## Architectural Review Board Staff Report

| <b>Project Type:</b> | Amended Site Development Plan   |
| <b>Meeting Date:</b> | April 14, 2020  |
| <b>Description:</b>  | <b>Fairfield Suites ASDP:</b> An Amended Site Development Plan, Landscape Plan, Lighting Plan, Architectural Elevations and Architect's Statement of Design for a 2.84-acre tract of land zoned "PC" - <i>Planned Commercial District</i> located northwest of the intersection of Conway Road and Chesterfield Parkway East. |

Figure 2: Color Site Plan

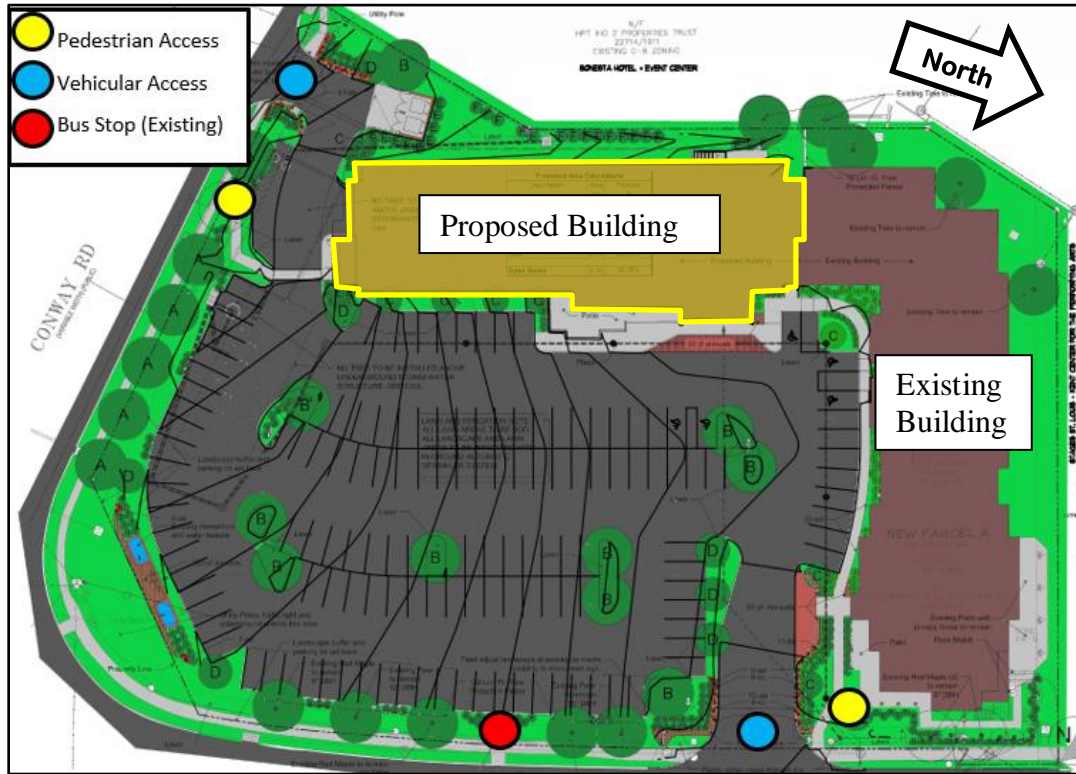
Two vehicular access points currently serve the site with a bus stop located along Chesterfield Parkway East. The proposed addition includes two (2) new pedestrian access points along both roads that continue through to the existing and proposed buildings while continuing to utilize the existing curb cuts entering the site. Figure 2 illustrates the location of each of these features.

Figure 4: Revised North Elevation

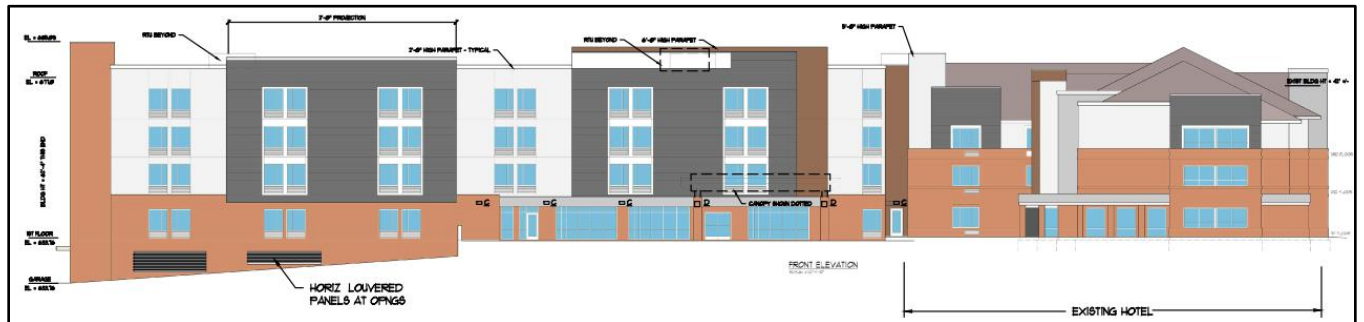
Since the previous ARB meeting, the applicant has made changes to the design of the existing building by adding massing elements from the proposed building to all elevations, as opposed to just the south elevation. The mending, or transition zone between the two buildings has also been updated to provide a more pronounced transition between the two structures, as noted on the revised eastern elevation. A comparison of original and revised elevations since the last ARB meeting is shown below:

Figure 8: Rooftop Unit Screening

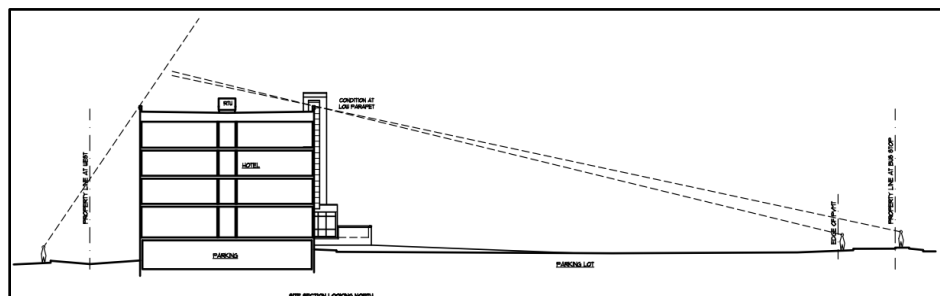
Other concerns were raised about how the Rooftop Mechanical Units were to be screened and whether or not the garage beneath the hotel would feature any sort of screening system on the open-air windows on the garage. After a brief discussion of these concerns, the applicant requested that no action be taken by the Board on this project until these issues are addressed. This report is intended to provide an update on how the current submittal relates to the City of Chesterfield Unified Development Code and Comprehensive Plan policies.

The trash enclosure will also be screened from the ground level of the proposed building by vegetation and one (1) honey locust tree between it and the property line to the west. Rooftop Mechanical Units (RTUs) will be screened by a combination of parapets at some locations and additional screening material where parapet screening will not be possible. Figure 8 below demonstrates how these units will be adequately screened.
